# **Report**

## **Second Assessment and Evaluation**

**”NEW COGENERATION FACILITIES  
SUPPLYING LESS CARBON INTENSIVE  
ELECTRICITY TO GRID AND STEAM  
AND/OR HOT WATER TO ONE OR MORE  
GRID CUSTOMERS”**

**REPORT NR.01 996 2120 9941**

**Figure 1: Generic scheme of the project participants and boundary**

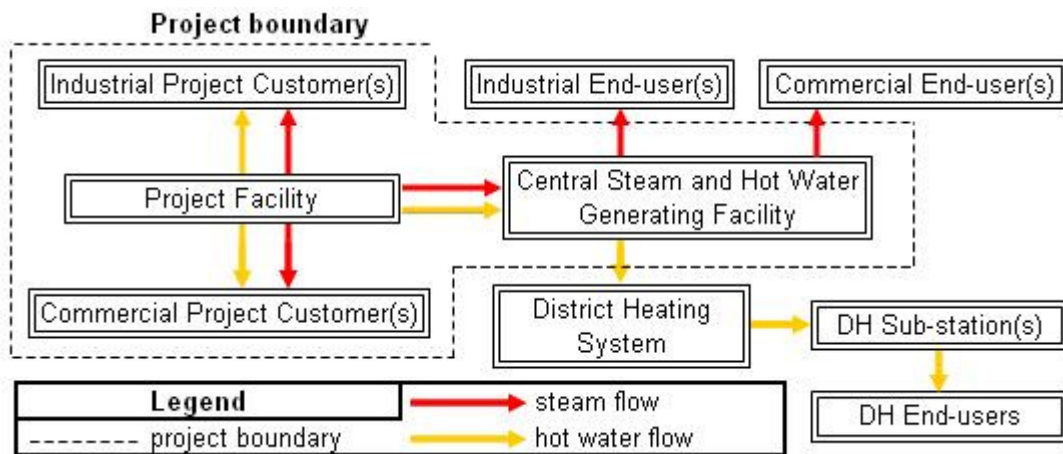
Figure 1 should be more generic, not limited to the project participants and companies involved in Skopje, Macedonia

*The scheme is made more generic. It will be in accordance with the generic names given to all entities that may be related to the project. The names chosen should be more intuitive and facilitating the quick grasp of their exact roles in the project or of their relations to project entities.*

The methodology description and related scheme was amended accordingly.
